COMMUNITY DEVELOPMENT DEPARTMENT REPORT

APPLICANT: Hawkins Companies

SUBJECT: H-2025-0007
Syringa Crossing Mixed-Use
Development (aka Hawkins Syringa
Crossing Subdivision) – AZ, CUP, PP

FA3. Mixed Use Community Concept Color Diagram with Markup

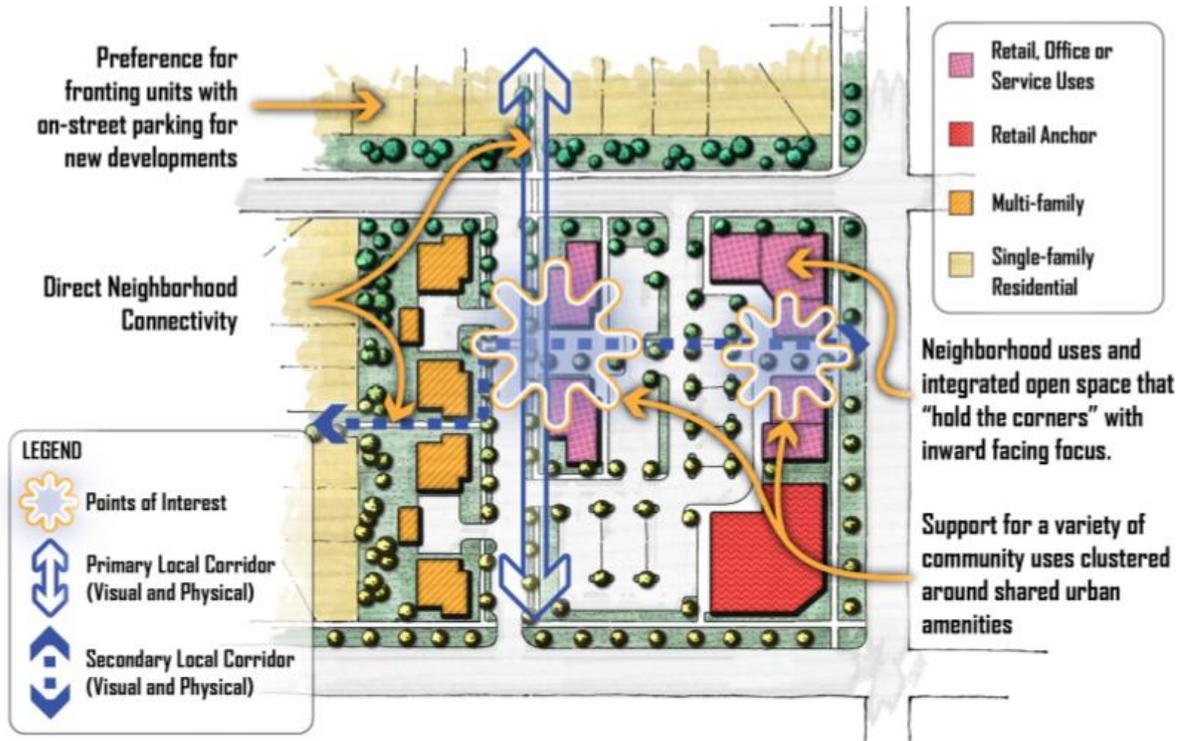
Development review for consistency with the Comprehensive Plan will consider the integration of use and holistic design sub-sections (below) in all mixed-use areas unless otherwise noted. To be successful, the principles outlined must be considered as interrelated features serving the basis of plan design. **Contiguous Mixed Use identified areas that are bisected by an arterial or highway are considered separate and independent areas for use and design integration and will be evaluated independently of each other per the Plan (pp. 3-14 & 3-16).**

E. Conceptual Development Plan for Annexation Area (dated: 1/6/26)

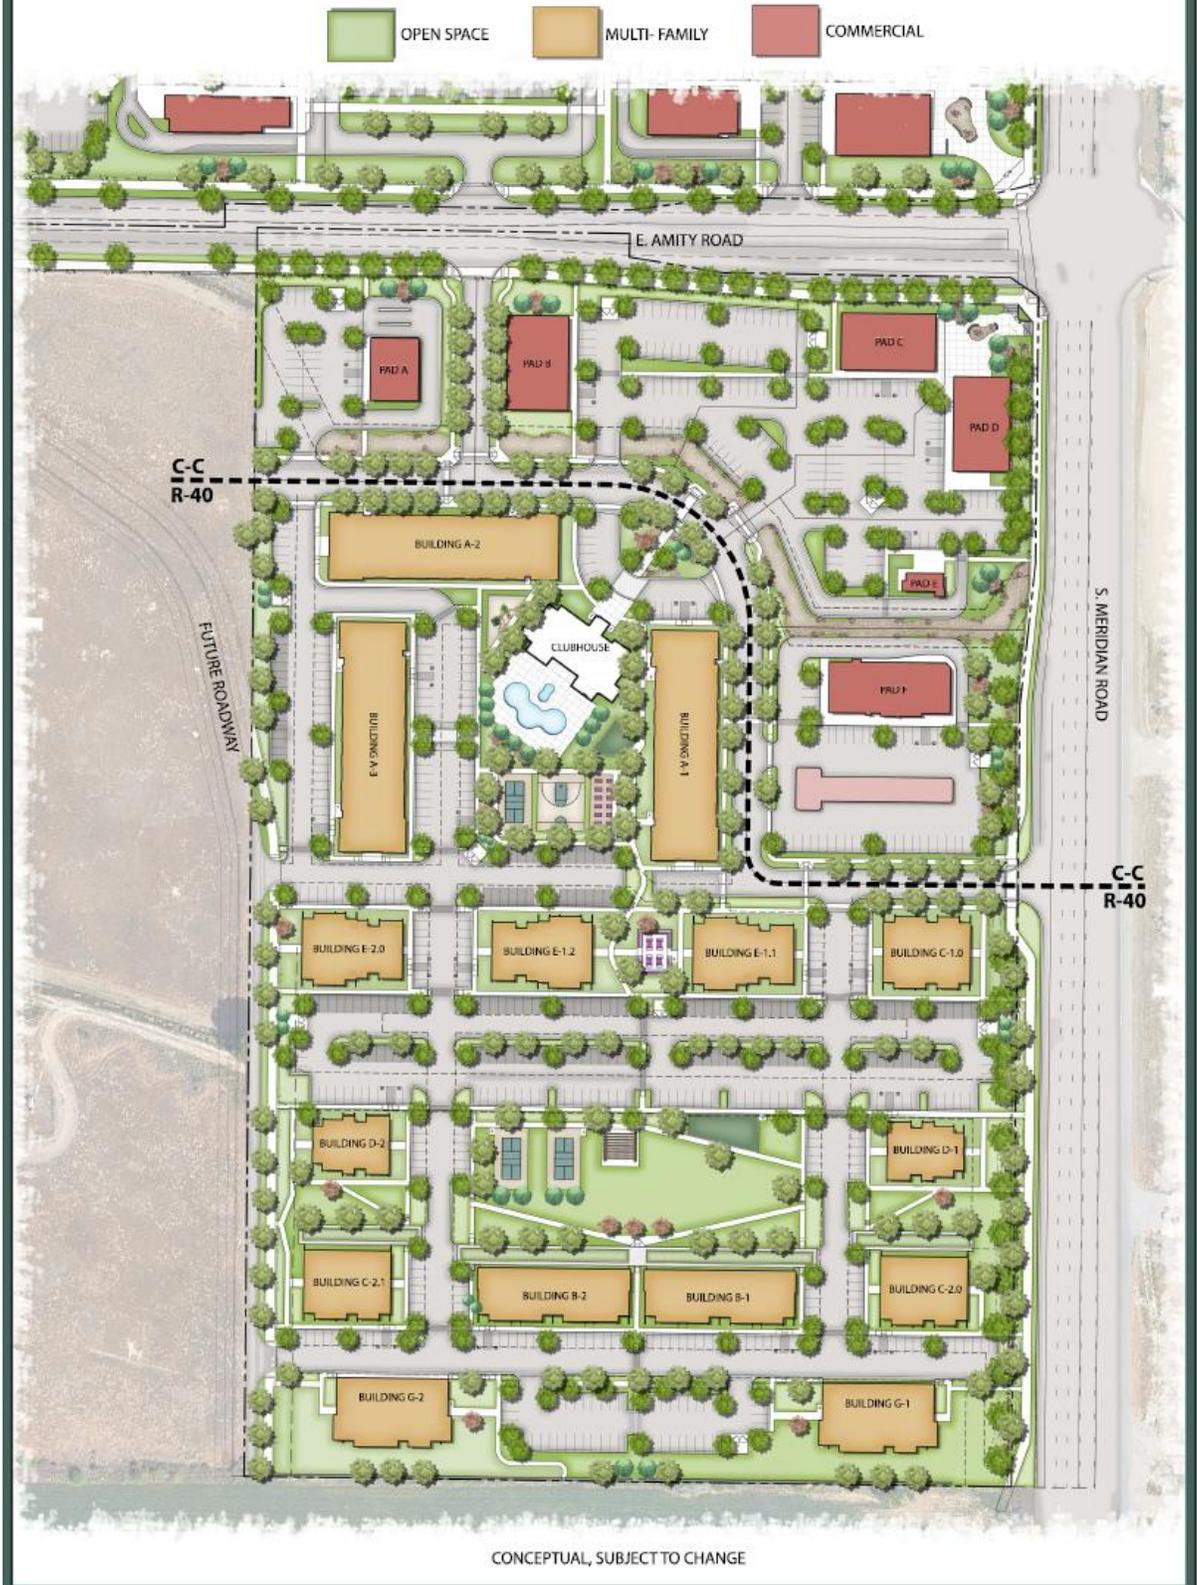
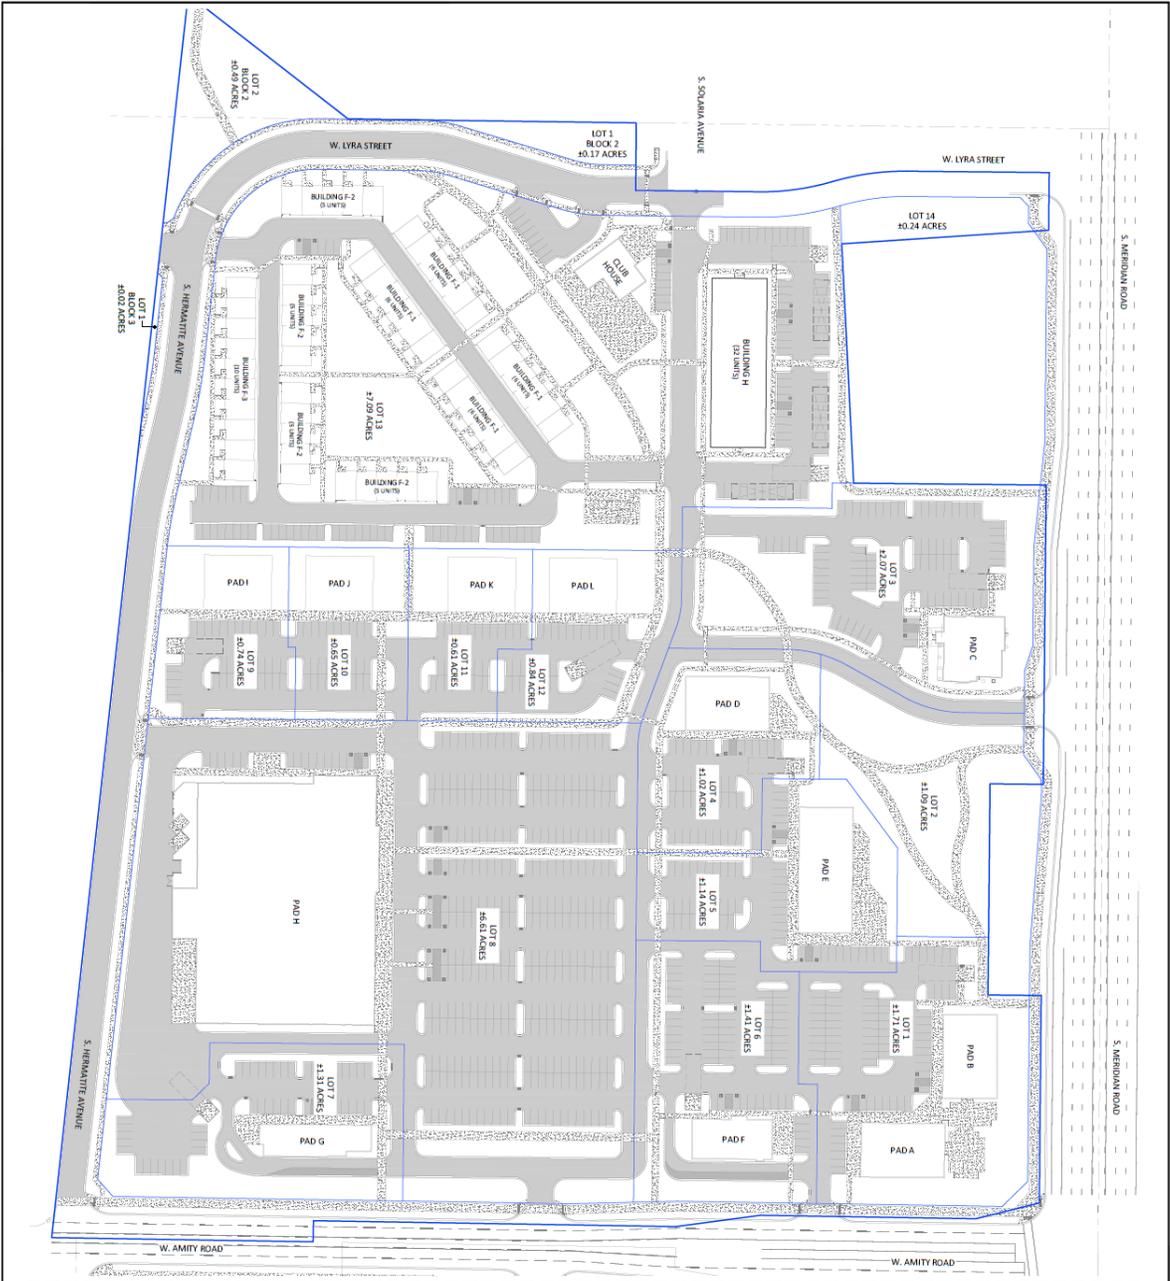
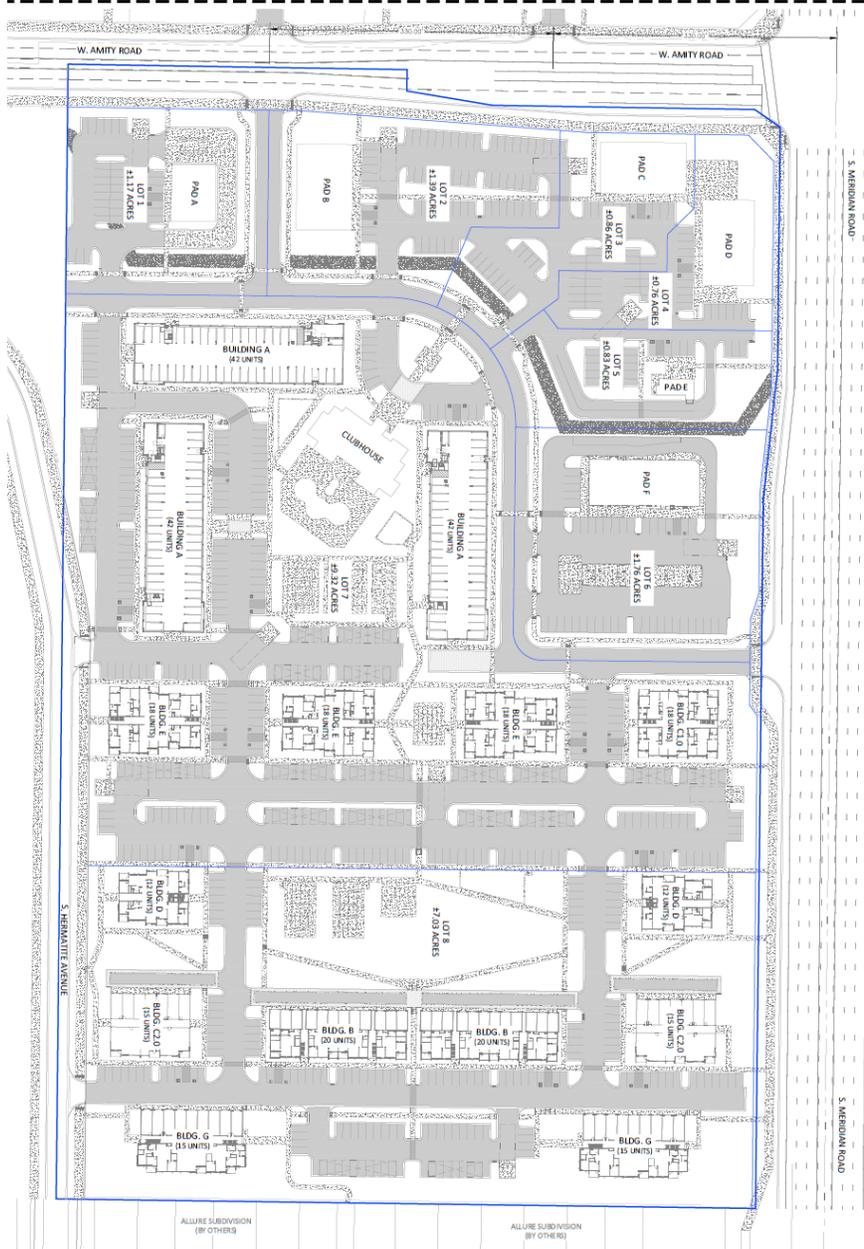
Issues: The proposed conceptual development plan and C-G zoning is not consistent with the general mixed use and MU-C principles in the Comprehensive Plan for the following reasons:

- The proposed development is not functionally integrated in holistic design and integration of uses per the design principles in the Plan (i.e. the uses function as individual components, not together, as desired).
- The southwest corner (SWC) of the development is 72% residential with a gross density of 18.23 units per acre, which is 22% more residential than the maximum allowed of 50% and 3.23 units per acre over the maximum allowed density of 15 units per acre. Commensurate

A conceptual development plan is proposed for the overall annexation area, included below in Section V.E., showing how the property is anticipated to develop with 423 multi-family dwelling units consisting of 4-story podium apartments with parking on the ground floor, 3-story garden-style walk-up apartments and 3-story townhome-style units; 146,840+/- square feet (s.f.) of commercial space and 20,800+/- s.f. of office space. The property at the SWC is proposed to annex and develop at this time (i.e. Phase 1) with a preliminary plat and conditional use permit for a multi-family development. The NWC is only proposed to be annexed at this time (i.e. Phase 2) with a conceptual development plan. Both portions are eligible for annexation separately as each are contiguous to City annexed land.

The conceptual development plan depicts two (2) driveway accesses via W. Amity Rd. as well as a collector street (S. Hermatite Ave.) access at the west boundary of the site in accord with the MSM; one (1) driveway access via S. Meridian Rd./SH-69; two (2) accesses via W. Lyra St., a collector street; and two (2) accesses via S. Hermatite Ave., a collector street. South Solaris Ave. is proposed to extend into the site 45’ from the north property line.

The conceptual development plan depicts one (1) driveway access via W. Amity Rd. and one (1) driveway/private street access via S. Meridian Rd./SH-69. A portion of a future collector street (Hermitite) via W. Amity Rd. is depicted along the southern portion of the west boundary of the site and stubs to the property to the south – the portion that connects to Amity Rd. is off-site on the adjacent property to the west and is not proposed to be constructed with this development. **The collector street access is needed for emergency service providers to adequately provide service the multi-family development; therefore, the collector street should be extended from W. Amity Rd. to the site prior to issuance of the first Certificate of Occupancy within the multi-family development.** Two (2) access driveways are proposed via Hermitite in the multi-family development.

The proposed plat depicts sidewalks as required. **The proposed conceptual development plan for the NWC doesn't include 10' wide sidewalks along the collector streets (Lyra/Hermatite) and should.**

- **The conceptual development plan for the SWC of the development should be revised to reflect residential uses comprising between 20% and 50% of the development area with gross densities ranging from 6 to 15 units/acre (of the residential area). Currently, 72% of the 24.45-acre site is residential at a gross density of 18.23 units per acre.**
- **If the NWC property is annexed, the conceptual development plan for that development should be revised to include driveway(s) accesses to the out-parcels (#R4622730010, #S1225449220 & #S1225449910) along S. Meridian Rd./SH-69 that currently take access via S. Meridian Rd./SH-69 for internal access from within the site.**

PROJECT: HAWKINS SYRINGA CROSSING SUB-MERIDIAN, IDAHO
DATE: 12/22/23
SCALE: 1" = 20'
PROJECT NO.: PPL5.0

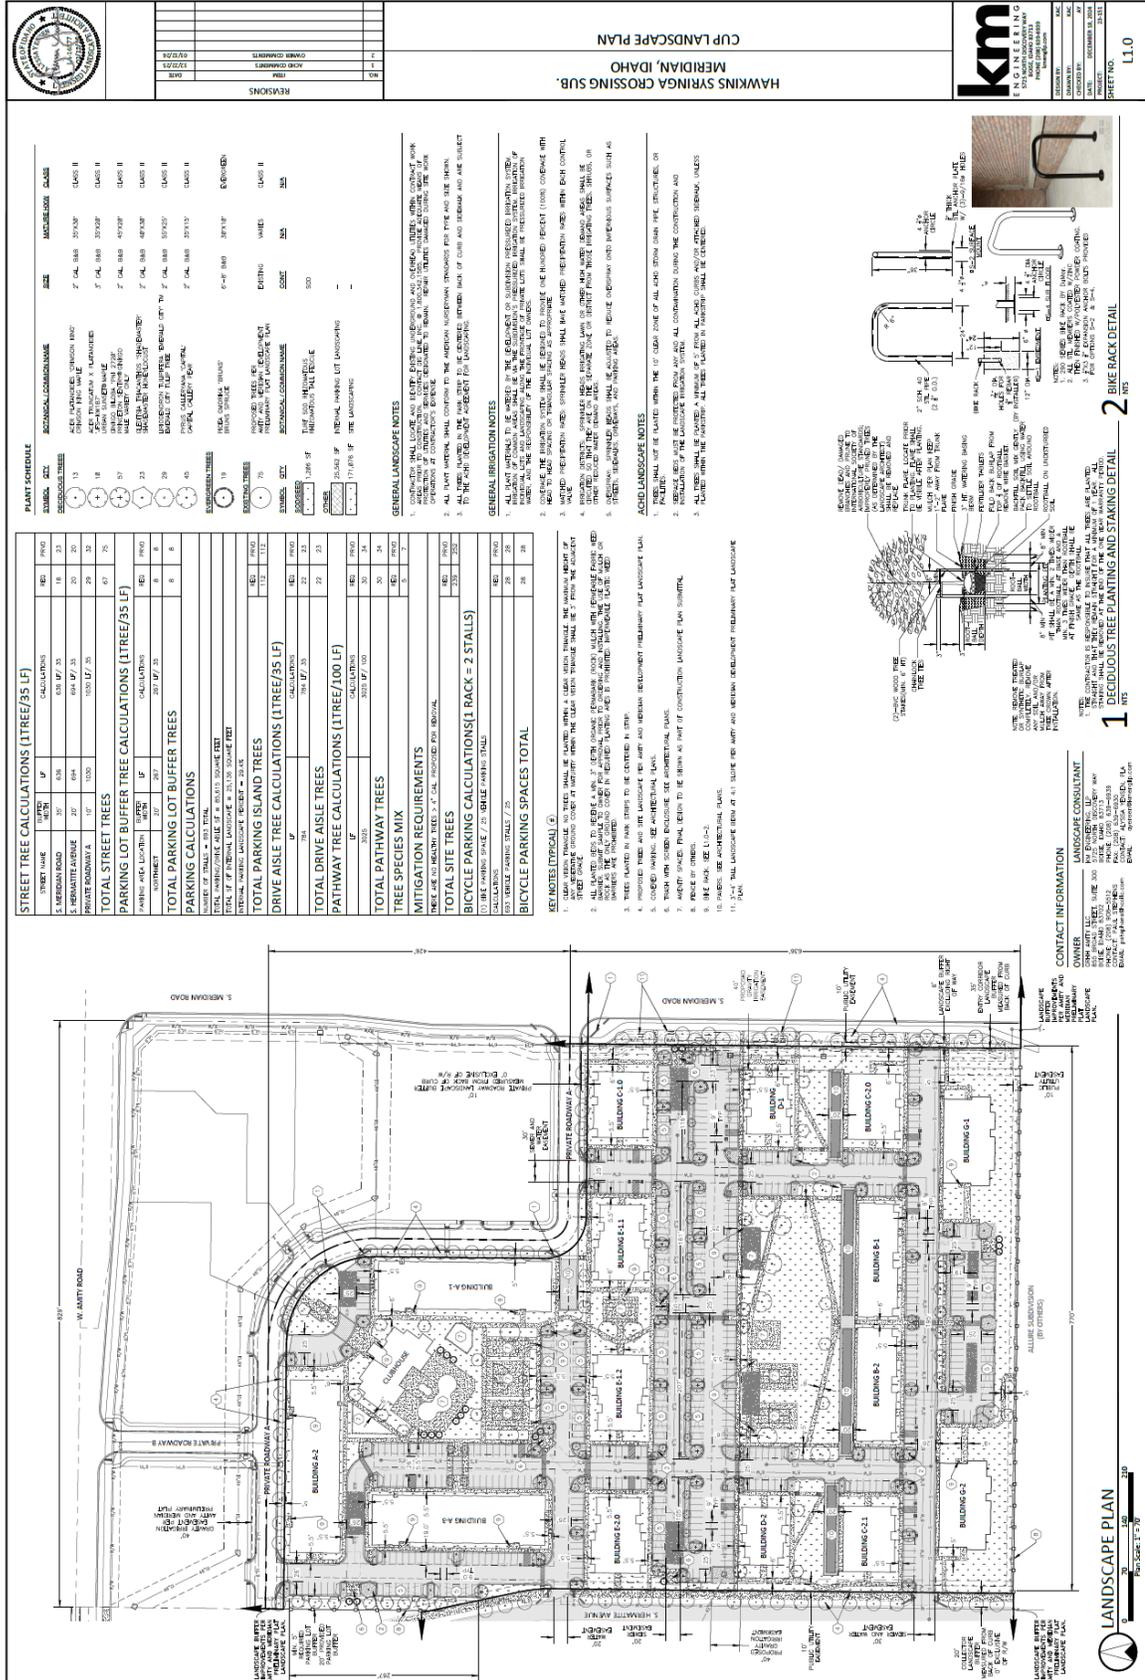
There are several existing trees on the SWC that will be removed with development, some in poor and some in good condition. The Mitigation Calculations shown on the landscape plan submitted with the preliminary plat included below in Section V.J, state 190 caliper inches are required for mitigation with 200 caliper inches provided, in accord with UDC standards.
